**Economic Commission for Europe****Inland Transport Committee****World Forum for Harmonization of Vehicle Regulations****Working Party on Automated/Autonomous and Connected Vehicles****Twenty-first session**

**Advanced Driver Assistance Systems and UN Regulation No. 79:  
Acceleration Control for Pedal Error****Proposal for the 01 series of amendments to UN Regulation  
on Acceleration Control for Pedal Error (ACPE)****Submitted by the experts from the Informal Working Group on  
Acceleration Control for Pedal Error\***

Annex 2, amend to read (addition of a letter "VP" in the marking and its reference in the text):

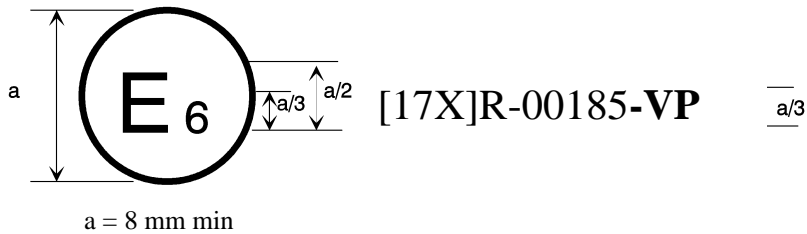
The above approval mark affixed to a vehicle shows that the vehicle type concerned has been approved in Belgium (E 6) with regard to the Acceleration Control for Pedal Error (ACPE) pursuant to UN Regulation No. [17X] (**marked with V for Vehicle and Wall. P for Pedestrian**). The first two digits of the approval number indicate that the approval was granted in accordance with the requirements of UN Regulation No. [17X] in its original form.
